**Client:** Manwel and Samira Shuwayhat  
**Project Location:** 160 Holmes Street, Livermore, California  
**Subject:** Revised Work Plan for Source Area Investigation  
**Report Date:** October 16, 2006

**Subject: Revised Work Plan for Source Area Investigation for Fuel Leak Case No. RO0000324, Livermore Gas and Mini-Mart, 160 Holmes Street, Livermore, California**

September 19, 2006

Subject: Fuel Leak Case No. RO0000324, Livermore Gas and Mini-mart, 160 Holmes Street, Livermore, CA

Sheet Name and Address  
**PROPOSED BORING LOCATION PLAN**  
 160 HOLMES STREET  
 LIVERMORE, CALIFORNIA

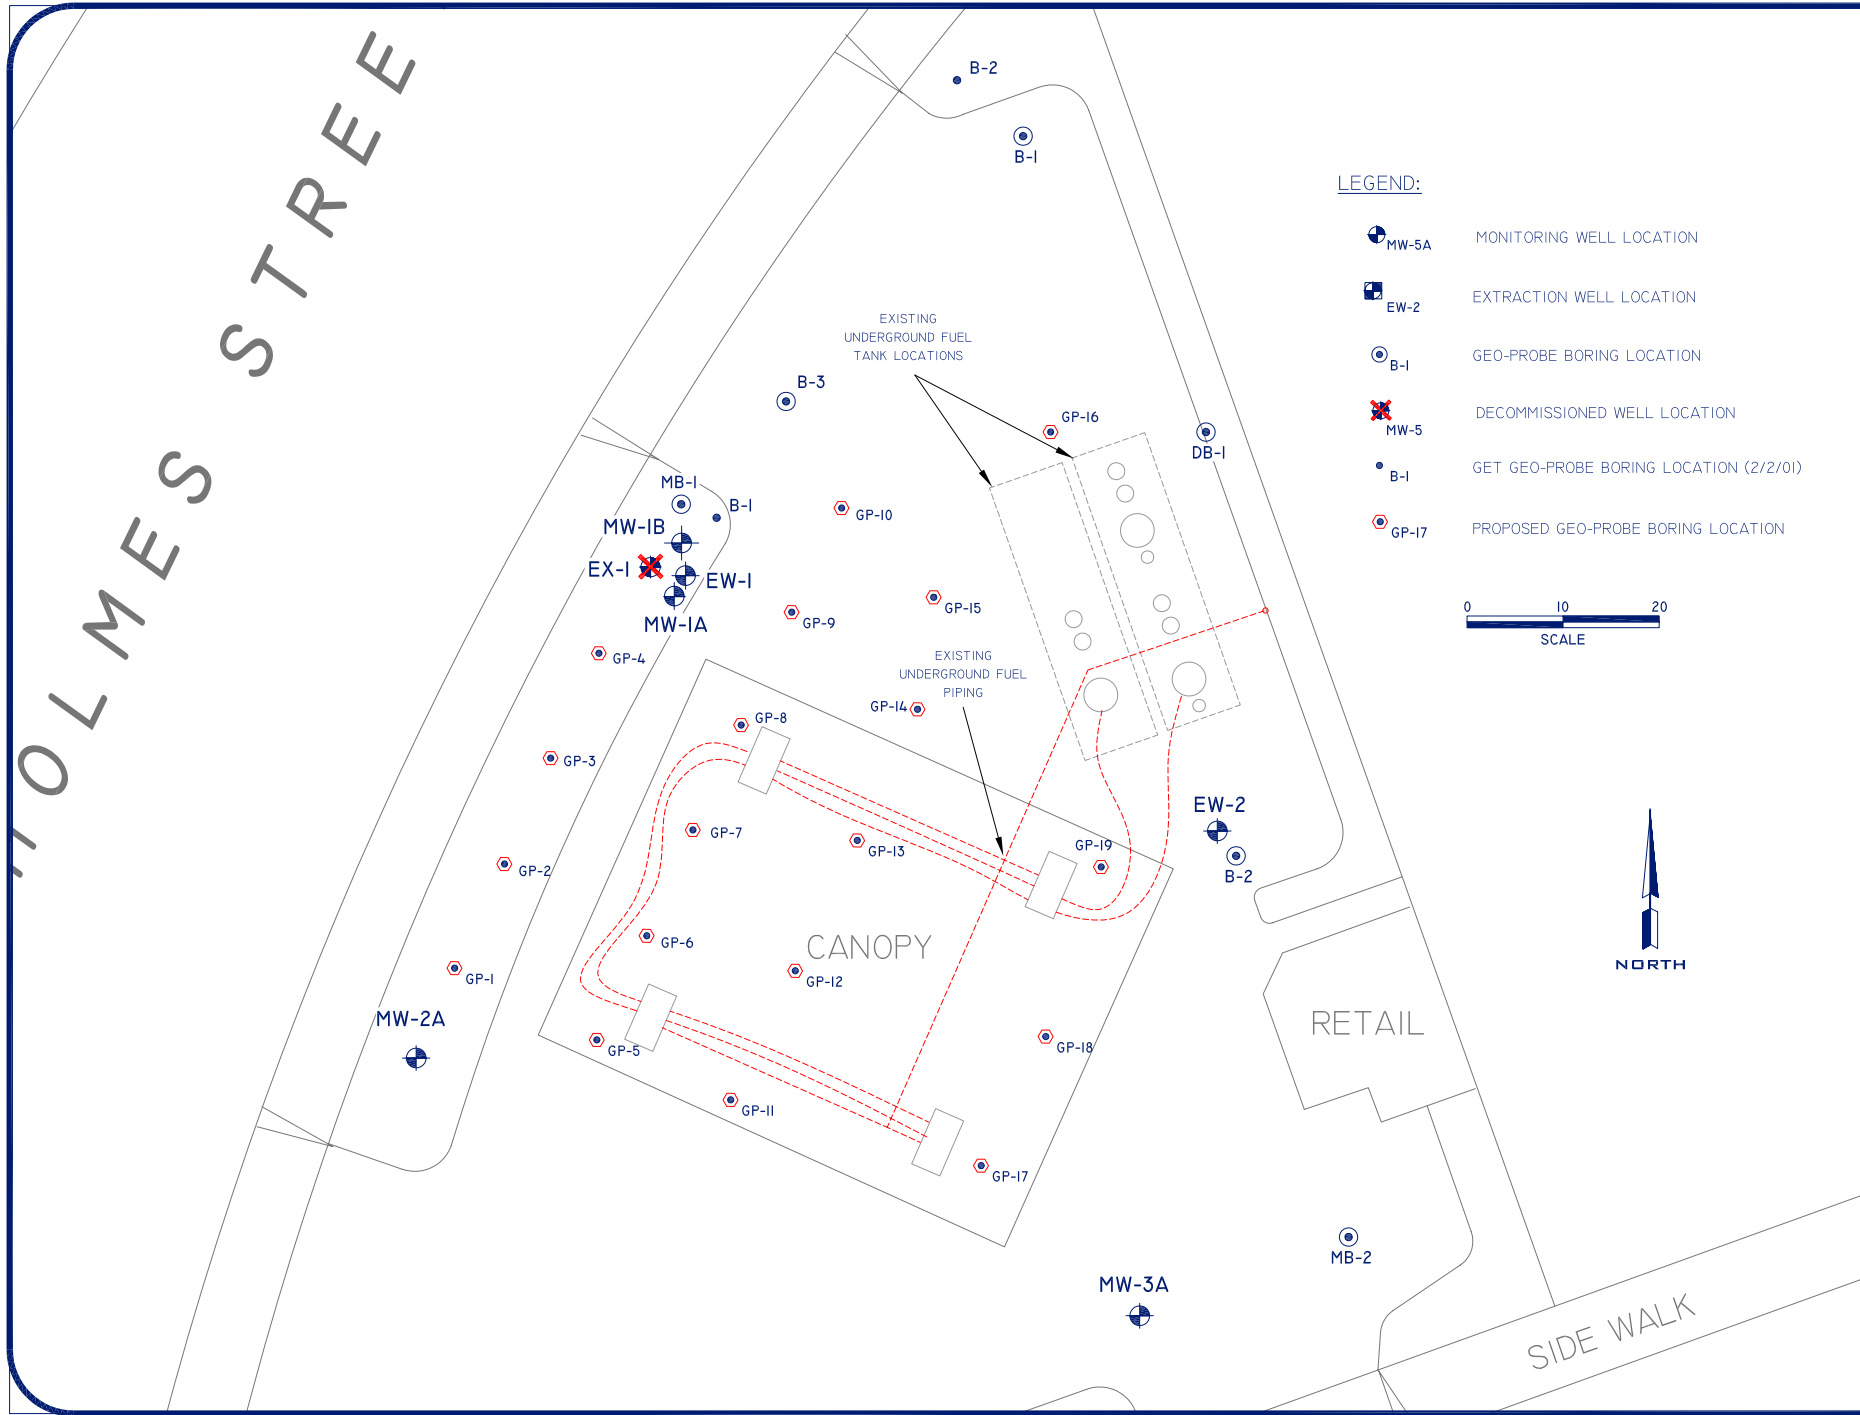
1. **Proposed Boring Locations.** The proposed locations for the source area investigation boreholes are acceptable.
2. **Proposed Sample Collection.** We concur with the proposed continuous soil sample collection for logging and screening. Soil samples are to be submitted for laboratory analyses from all depths where staining, odor, or elevated photoionization readings are observed. If no staining, odor, or elevated photoionization readings are observed, we request that the soil samples collected from depths of 8, 24, and 28 feet bgs be analyzed from each soil boring regardless of screening results. We do not concur with the proposal to only analyze soil samples collected from depths of 24 and 28 feet bgs if elevated concentrations of petroleum hydrocarbons are detected in the soil sample collected at 20 feet bgs. This request is based upon review of data from previous soil borings, which indicate that results from the soil sample collected at 20 feet bgs may not provide an indication of soil contamination below 20 feet bgs. As shown on Table 1, TPHg was frequently not detected in soil samples collected from 20 feet bgs but was detected in the same boring in soil samples collected at depths of 24 and 28 feet bgs. As an example, the soil sample collected at 20 feet bgs from boring MB-3 did not contain detectable concentrations of TPHg but the soil sample collected from 28 feet bgs in boring MB-3 contained 1,400 milligrams per kilogram of TPHg.

ACEH concurred with Allterra's proposed locations for Geoprobe<sup>®</sup> borings GP-1 through GP-19. The proposed boring locations are presented in Figure 1.

Sheet Name and Address  
 TYPICAL SOIL GAS SAMPLE PROBE  
 CONSTRUCTION DETAIL  
 160 HOLMES STREET  
 LIVERMORE, CALIFORNIA

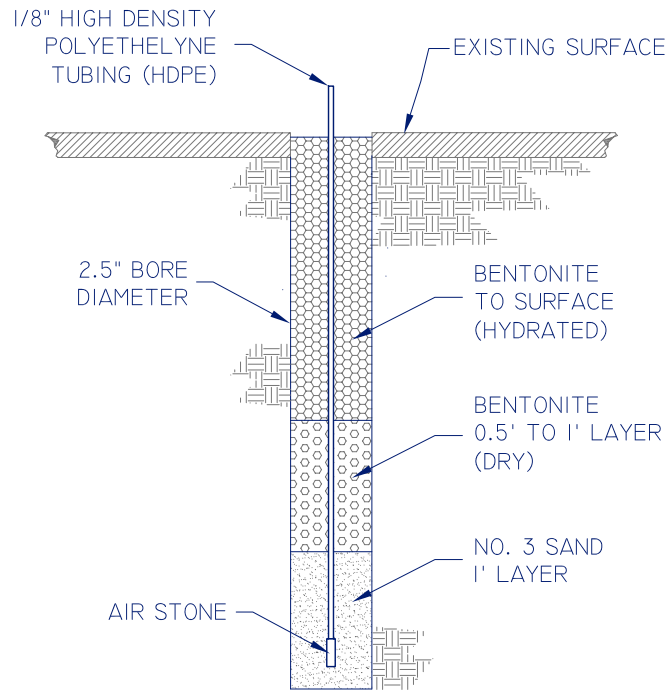
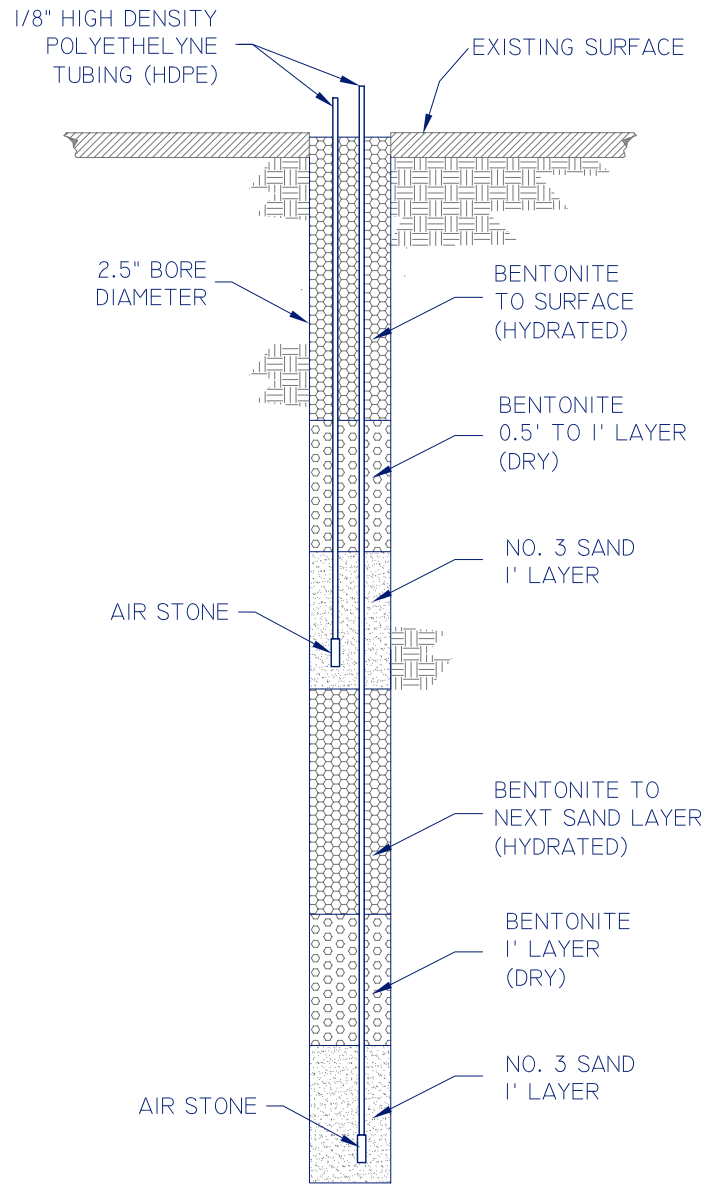
4. **Soil Vapor Sampling.** In order to help assess whether soil vapor extraction we request that one or more soil vapor samples be collected from each soil boring. The proposed depths of the soil vapor samples may be based upon results from continuous logging and screening. Please present plans for soil vapor sampling from each of the proposed soil borings in the revised Work Plan requested below.

**Soil Gas Probe Installation and Construction:** The permanent or semi-permanent gas probe will be installed using a Geoprobe<sup>®</sup> drill rig. The drill rig will install a boring to the desired depth and the soil gas probe will be constructed. The gas probe will be constructed with 1/8-inch high-density polyethylene (HDPE) tubing from surface grade to the desired sample depth, where a porous media (air stone) probe tip will be installed. The probe tip will be emplaced midway within a minimum of one (1) foot of sand pack and at least 0.5-foot of dry granular bentonite will be emplaced on top of each sand pack to preclude the infiltration of hydrated bentonite grout. The borehole will be grouted to the surface with hydrated bentonite. With respect to deep probe construction with multiple probe depths, the borehole will be grouted between probes. At least 0.5-foot of dry granular bentonite will be emplaced between the filter pack and the grout at each probe location. A detailed description of sample probe construction procedures is presented in Appendix B. Figure 2 presents typical soil gas probe construction details.
